Product Change Notification

POWER TVS DIODES

Bourns® Model PTVS10-0xxC-M Series High Current Power TVS Diodes *Change to Terminal Layout*

Existing Terminal Layout

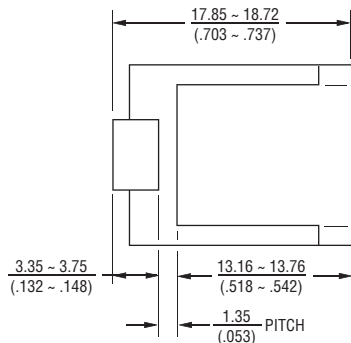
In the spirit of continuous improvement, Bourns is making a change to the pad layout for the Bourns® Model [PTVS10-0xxC-M](#) Series High Current Power TVS Diodes. The pitch between the two terminals is being increased from 1.35 mm to 2.15 mm.

The change to the terminal layout has no impact on the form, function, quality or reliability of the product. The only impact to “fit” is the change in terminal layout for increased pitch. The product marking and label will remain unchanged.
